Department of Environmental Quality

RE: Draft Remedial Design Investigation Work Plan  
Willamette Cove Uplands  
ECSI# 2066

## Attachment 1: Willamette Cove Decision Unit Design

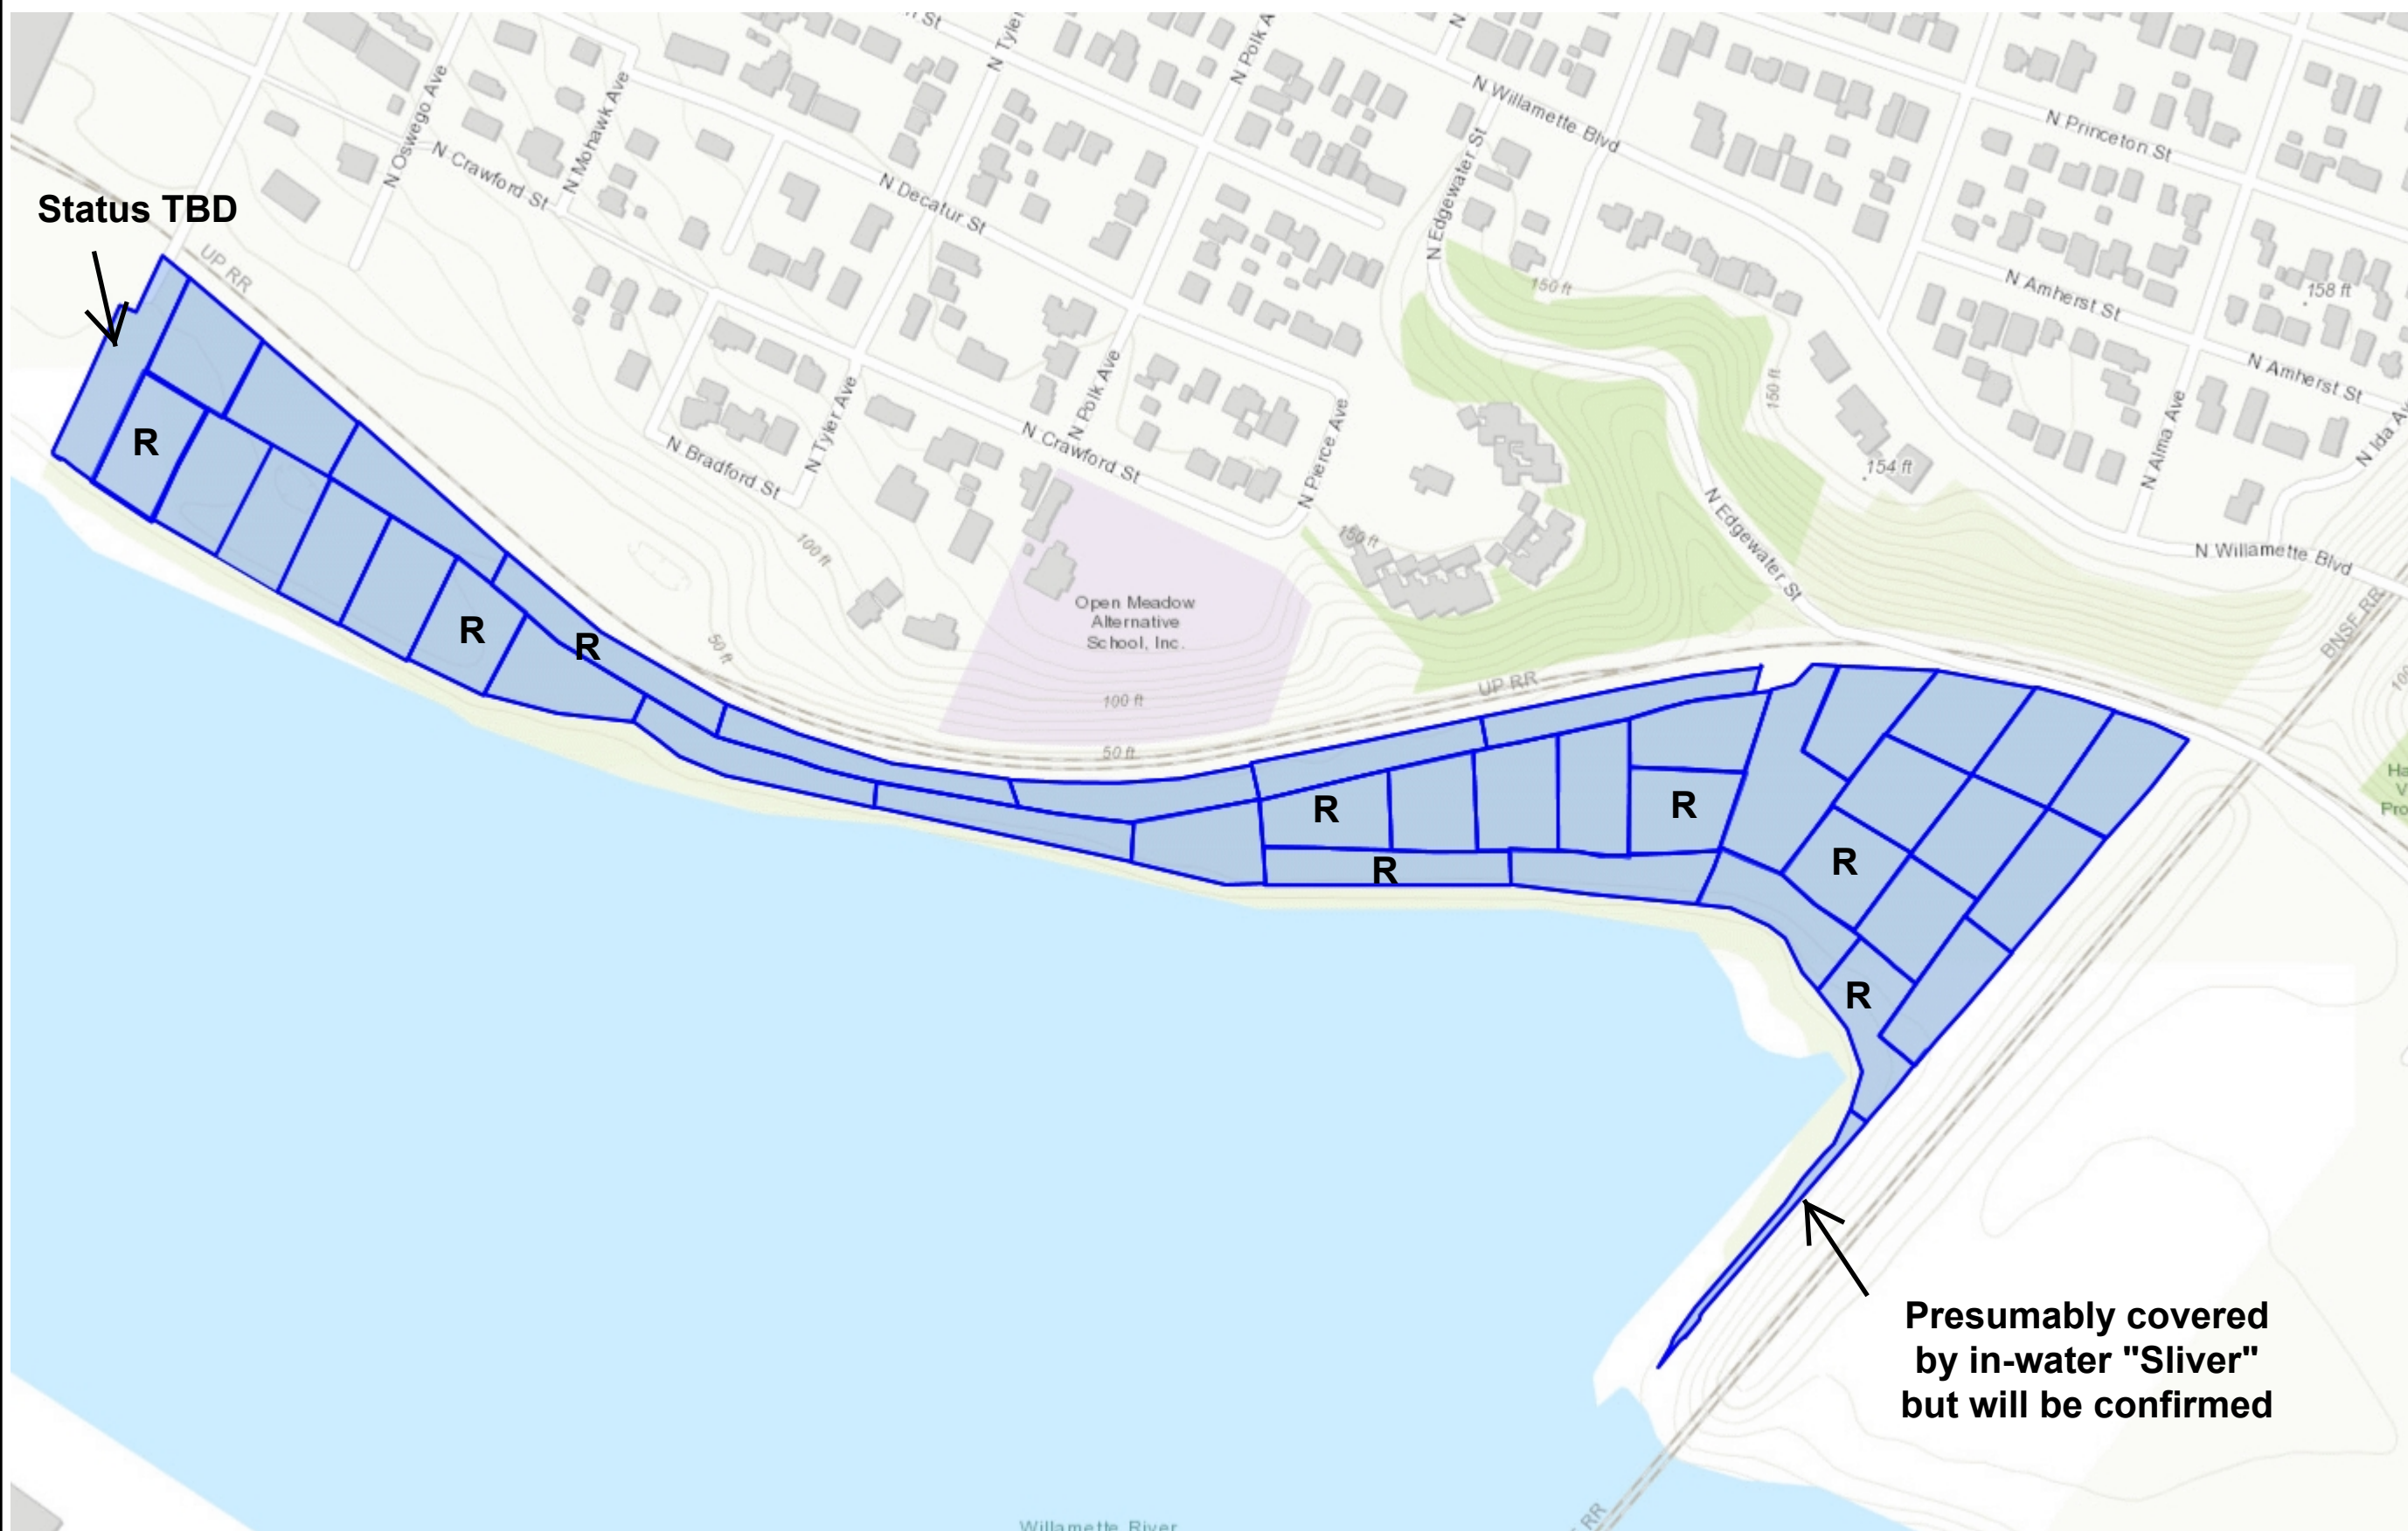
- on field conditions. Please provide a decision tree for identifying how the selection of sampling method will be made.
- b. Regarding field replicates, DEQ accepts 20% of DUs for 30 increment DUs. See attached map with recommended replicate locations and DU design. Replicate locations provided consider site use, soil and habitat type, potential presence of hot spots, and the need for replication depth.

13. Figures 5 through 7. DEQ appreciates the effort that went into factoring human and ecological risk, and past removal activities, in developing DUs illustrated in the work plan figures. As noted in General Comment No. 1 above, DEQ has a number of revisions and has prepared the attached map for consideration. We want to discuss DU design and anticipate further refinement, and once better clarity regarding site boundaries and TOB is provided. The incorporation of the conceptual site model and site layout of process areas and source areas is critical to the design of decision units to ensure confidence in the use of the data for decision-making. Accordingly, DEQ has the following recommendations to the DU design:

- a. DEQ feels the recommended 0.5 acre DU can be achieved with some adjustments to DU configurations and as needed incorporating additional DUs.
    - b. Please see comments above regarding Richmond Ave. on the Western Parcel and adjacent to the railroad on the Eastern Parcel. Additional discussion is needed to determine if supplemental DUs are necessary to characterize these areas.

- historical site development, roads, trails, and soil piles. For example, borders of DUs should delineate and not traverse these features and removal areas (e.g., SU-17, and SU-15 and SU-16).

- d. Delineation of the concrete pad is needed to refine and properly consider the area of adjacent DUs.
  - e. DEQ reviewed historical aerial photos and is suggesting modifications to the DUs using criteria outlined above. This includes consideration of site use features and operations, the north/south bifurcation of the site with filling, roads, and industrial development. The attached map illustrates these modifications.

- b. Please see DEQ's recommended modifications to the locations and sizes of the DUs in the attached map.
  18. Appendix C, Section 5.3, Sample Processing Procedures. This section does not indicate the specific methods used for each of the laboratory sampling steps. This will be critical in representatively processing the 5,500 grams of soil from each DU. Given the size and scope of this work plan, a site-specific laboratory SOP that details the proposed laboratory methods should be provided. DEQ advises the following:

All DUs approx 0.5 acres except:  
1. West Parcel Sliver: 0.57 acres  
2. Concrete Pad: 0.8 acres  
3. East Parcel Sliver: 0.2 acres
